Amendments to the Drawings:

USSN 10/060,550
MCA-490D US
Replacement Sheet

Prior Art
Fig. 1

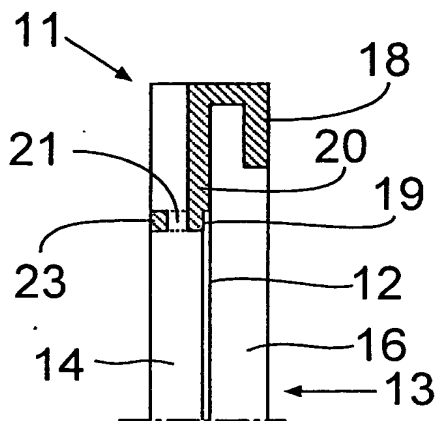
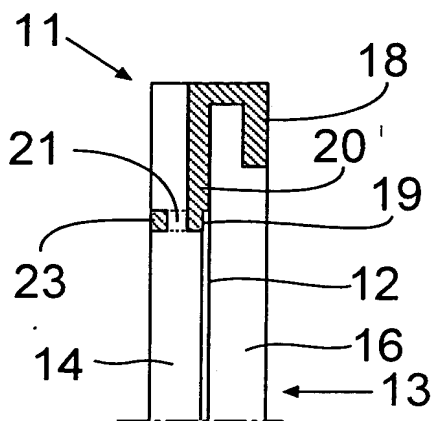
The attached two sheets of drawings include changes to Figure 1 and Figure 2(b). These sheets which include Figures 1- 3(b), replace the original sheets including Figures 1-3(b). In Figure 1 and Figure 2(b), the previously omitted descriptor "Prior Art" has been added.

*Descriptor
Added*

Fig. 2b
Prior Art

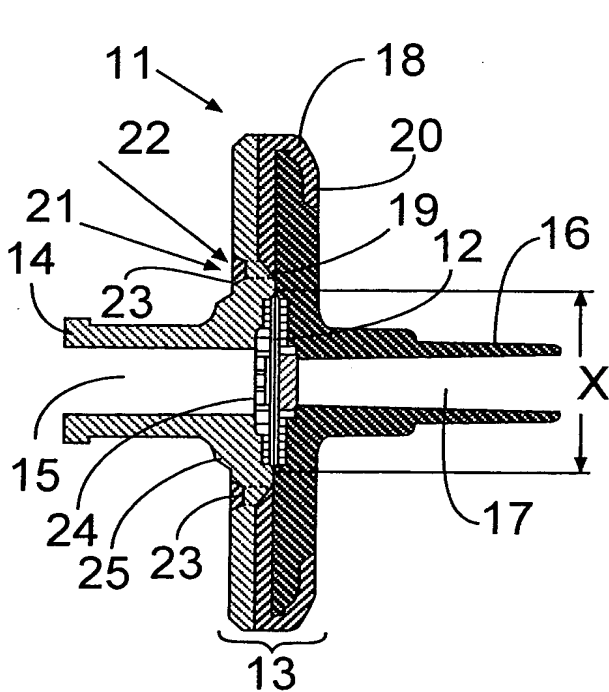
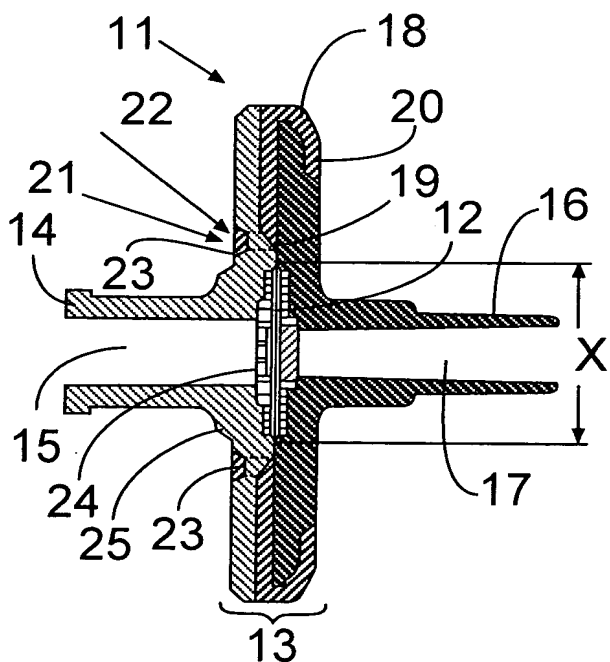
Descriptor
Added
